PENNSYLVANIA ELECTRIC COMPANY
THREE MILE ISLAND NUCLEAR STATION UNIT 1

Operating License No. DPR-50
Docket No. 50-289
Technical Specification Change Request No. 45

Technical Specification Change Request No. 45

Figure 2.1-1

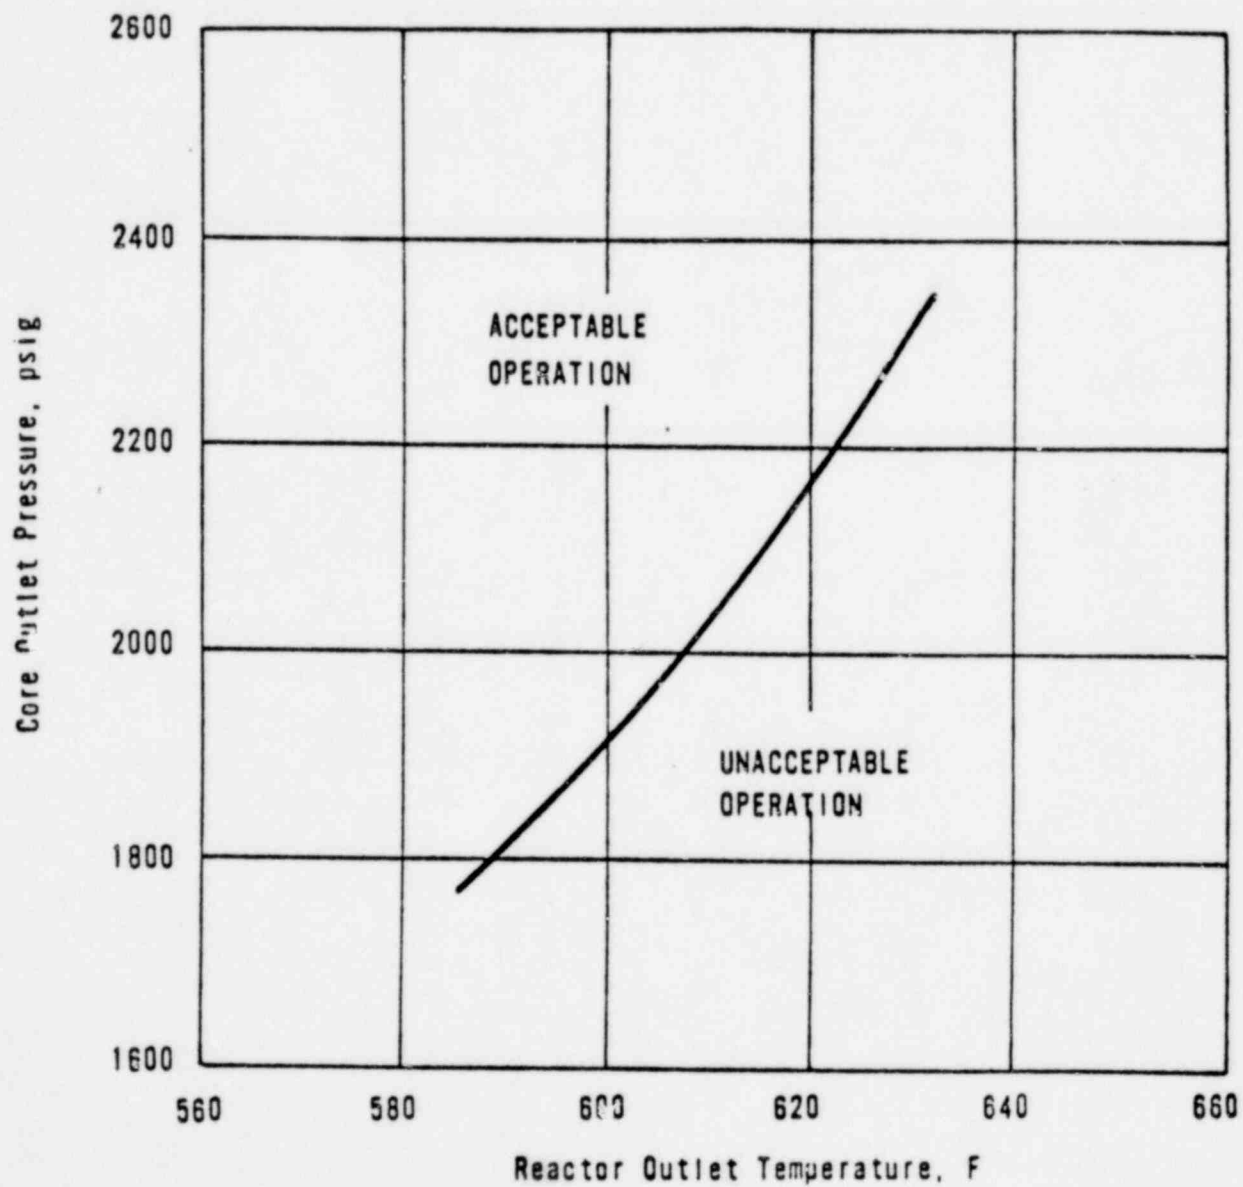
The Licensee requests that the attached changed pages replace pages v, vi, vii, 1-5, 2-3, 2-5, 2-6, 2-7, 3-1, 3-2, 3-34, 3-34a, 3-35, 3-35a, 3-36, 4-59 figures 2.1-1, 2.1-2, 2.1-3, 2.3-1, 2.3-2, 3.5-2A through 3.5-2J and table 2.3-1 of the existing technical specifications.

These changes are necessary to ensure safe operation of TMI-1 at a rated core power of 2535 MWt for the duration of Cycle 3 and are based on a Cycle 2 burnup of 253 ± 10 EFPD.

The curve of Figure 2.1-1 is the most restrictive of all possible reactor coolant pump-maximum thermal power combinations shown in Figure 2.1-3. The curves of Figure 2.1-3 represent the conditions at which a minimum DNBR of 1.3 is predicted at the maximum possible thermal power for the number of reactor coolant pumps in operation or the local quality at the point of minimum DNBR is equal to 22 percent, (3) whichever condition is more restrictive.

Figure 2.3-1

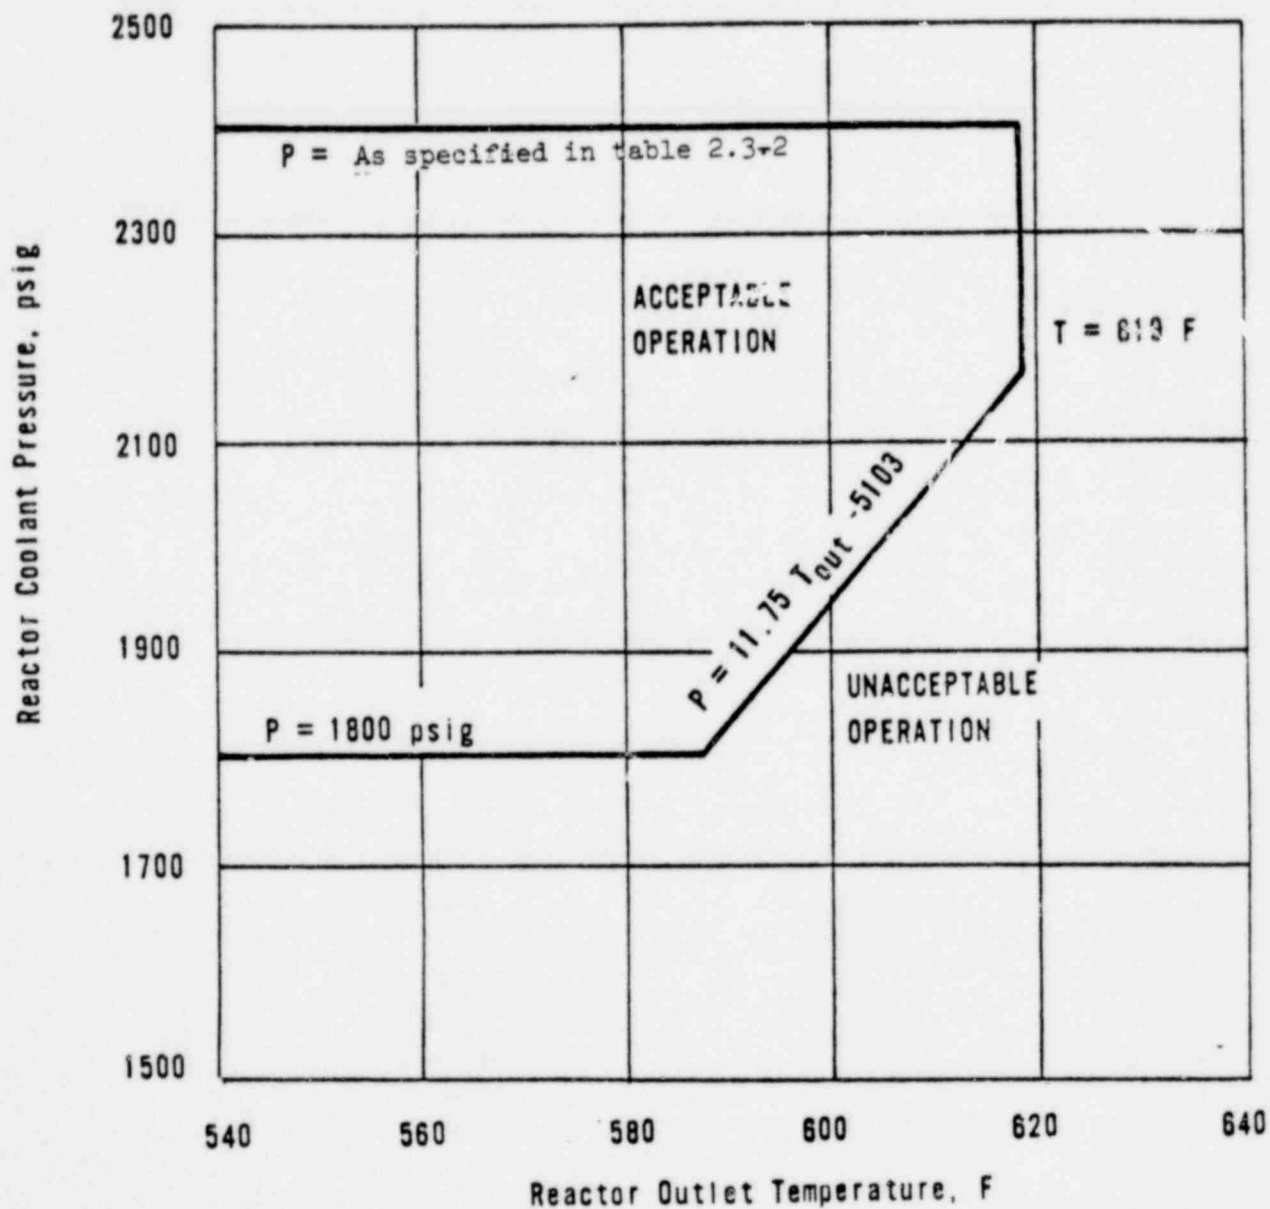
During a startup accident from low power or a slow rod withdrawal from high power, the system high pressure trip set point is reached before the nuclear overpower trip set point. The trip setting limit shown in Figure 2.3-1 for high reactor coolant system pressure has been established to maintain the system pressure below the safety limit (2750 psig) for any design transient. Due to calibration and instrument errors, the safety analysis assumed a 30 psi pressure error in the high reactor coolant system pressure trip setting.

The low pressure (1800 psig) and variable low pressure (11.75 Tout - 5103) trip setpoint shown in Figure 2.3-1 have been established to maintain the DNB ratio greater than or equal to 1.3 for those design accidents that result in a pressure reduction (3, 4).

The high reactor coolant outlet temperature trip setting limit (619 F) shown in Figure 2.3-1 has been established to prevent excessive core coolant temperatures in the operating range.

Figure 2.1-3

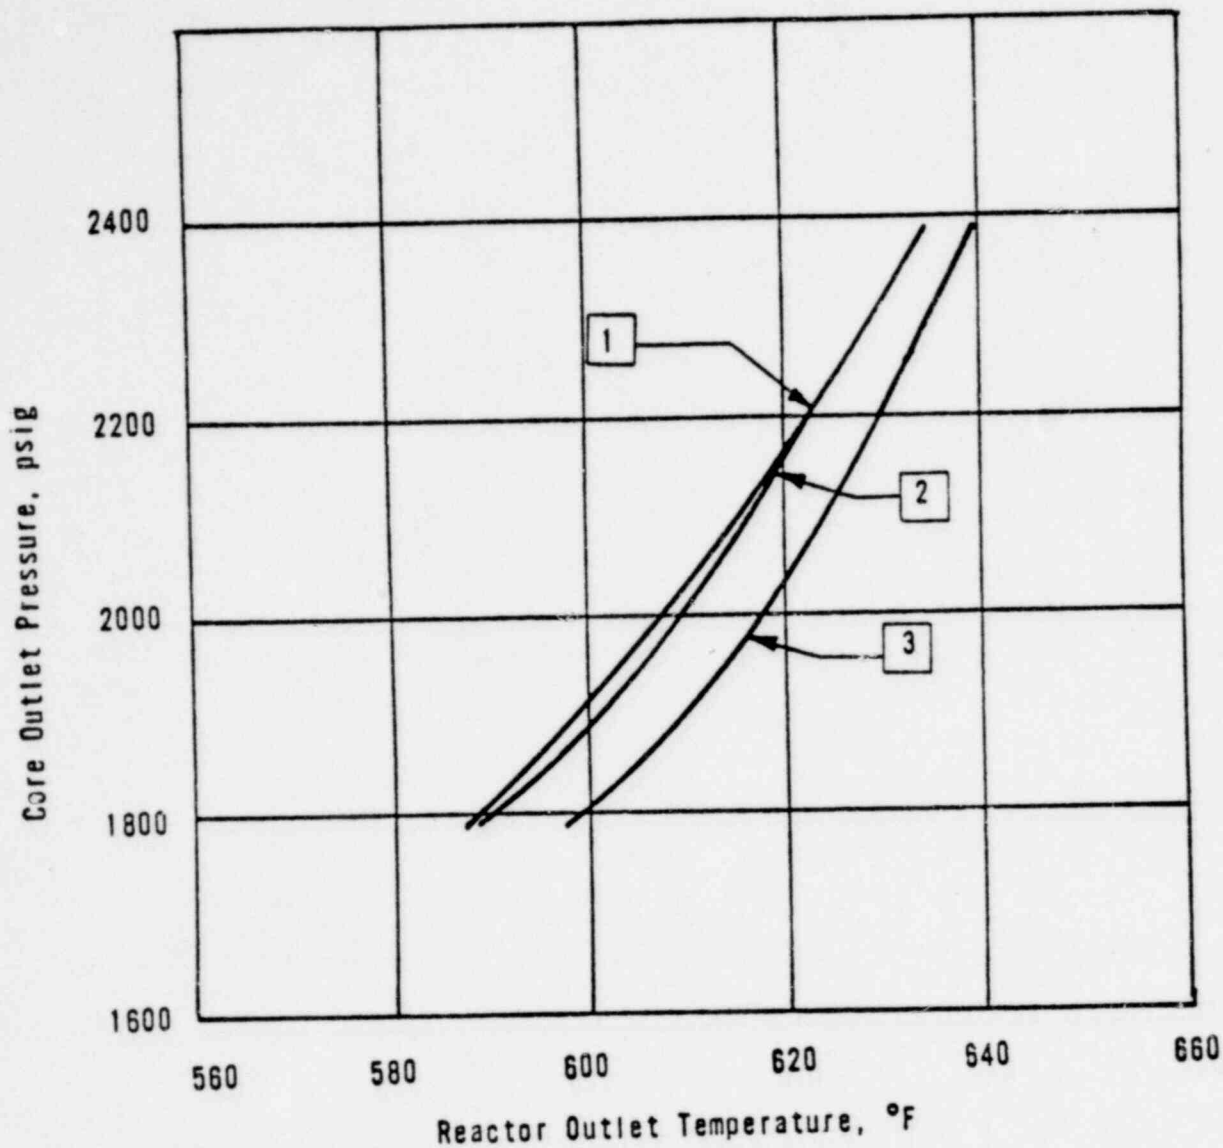
Using a local quality limit of 22 percent at the point of minimum DNBR as a basis for curve 3 of Figure 2.1-3 is a conservative criterion even though the quality at the exit is higher than the quality at the point of minimum DNBR.

For each curve of Figure 2.1-3, a pressure-temperature point above and to the left of the curve would result in a DNBR greater than 1.3 or a local quality at the point of minimum DNBR less than 22 percent for that particular reactor coolant pump situation. Curve 1 is more restrictive than any other reactor coolant pump situation because any pressure/temperature point above and to the left of this curve will be above and to the left of the other curves.

Figure 2.3-2

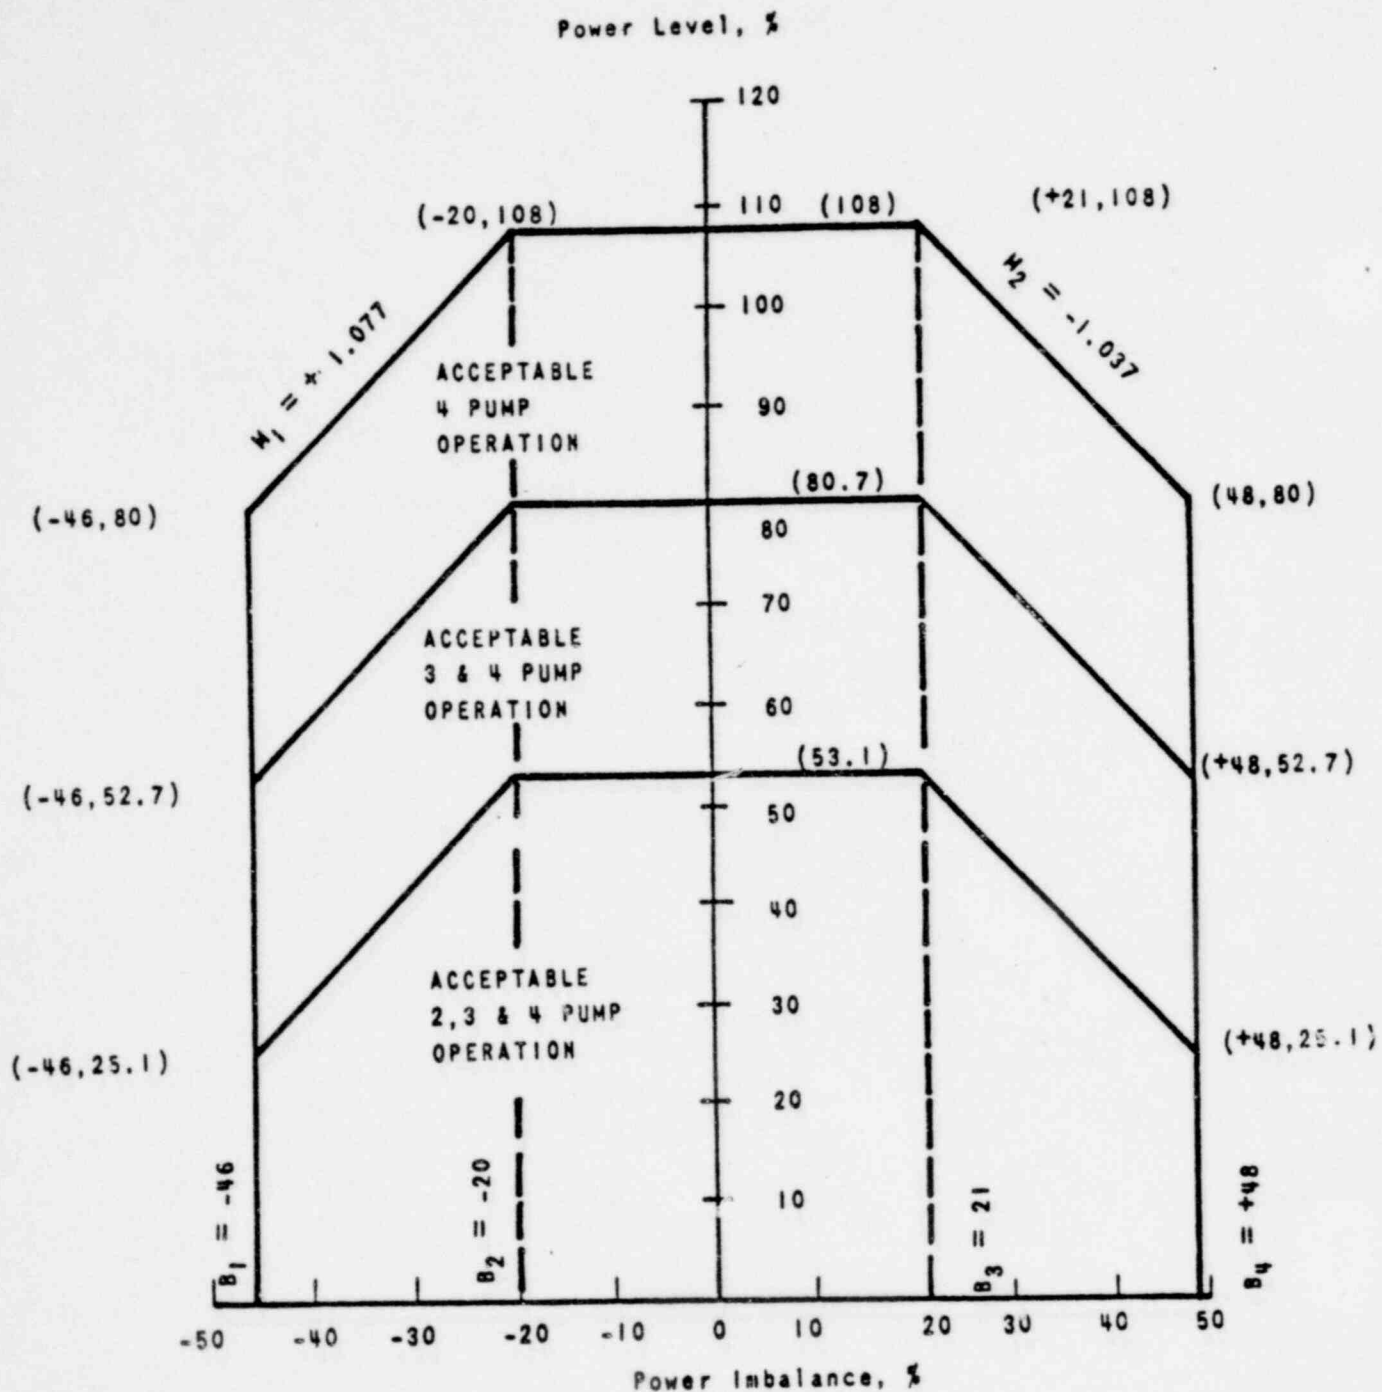
- 2.3.1 The reactor protection system trip setting limits and the permissible bypasses for the instrument channels shall be as stated in Table 2.3-1 and Figure 2.3-2.

Figure 3.5-2A

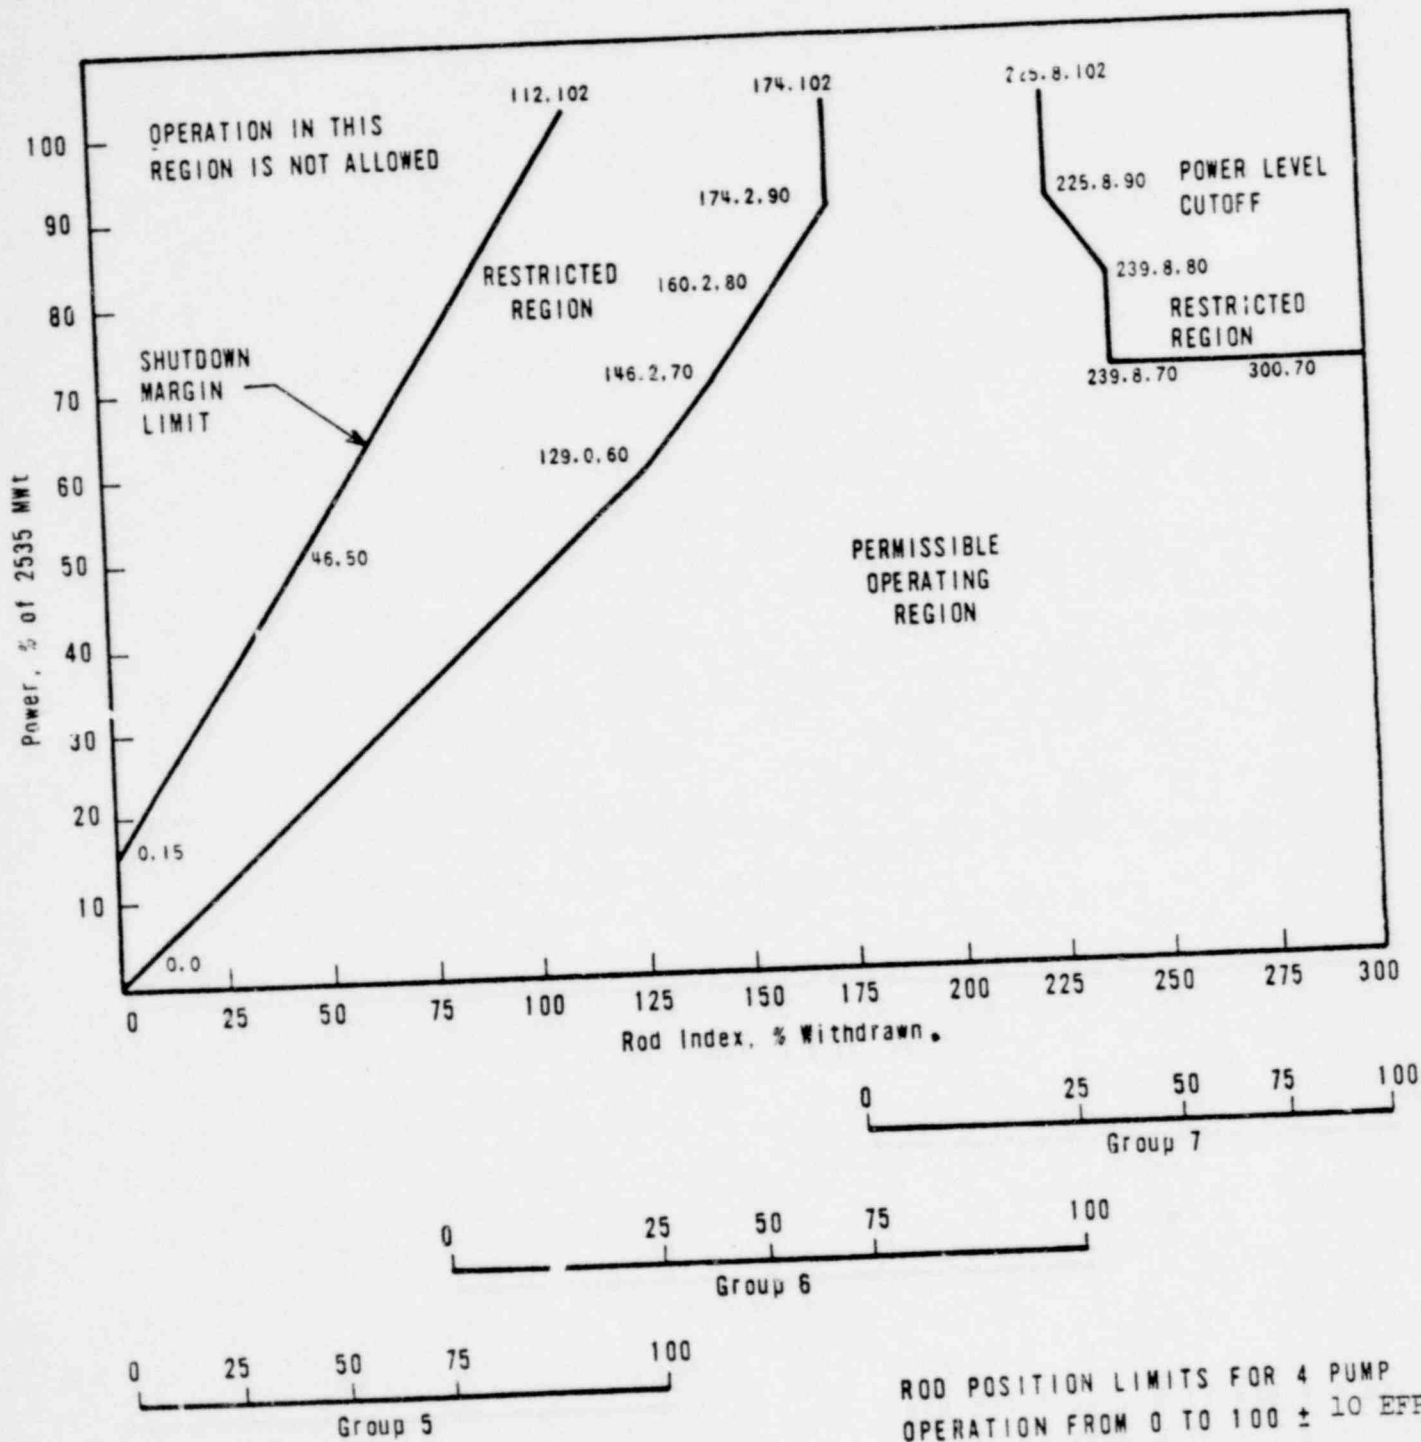
Revised quadrant tilt limits are proposed to clarify how the tilt limits should be applied based on the method used in determining tilt. The revised tilt limits are more restrictive than formerly used resulting in additional operating flexibility for the rod insertion limits while at the same time not reducing the degree of conservatism that would exist had the insertion limits been based on a larger tilt value.

- d. Except for physics tests if quadrant tilt exceeds the tilt limit power shall be reduced immediately to below the power level cutoff (see Figures 3.5-2A, 3.5-2B and 3.5-2C). Moreover, the power level cutoff value shall be reduced 2 percent for each 1 percent tilt in excess of the tilt limit. For less than four pump operation, thermal power shall be reduced 2 percent of the thermal power allowable for the reactor coolant pump combination for each 1 percent tilt in excess of the tilt limit.

2. The control rod group withdrawal limits (Figures 3.5-2A, 3.5-2B, 3.5-2C, 3.5-2D, 3.5-2E, 3.5-2F, 3.5-2K, 3.5-2L, and 3.5-2M) shall be reduced 2 percent in power for each 1 percent tilt in excess of the tilt limit.
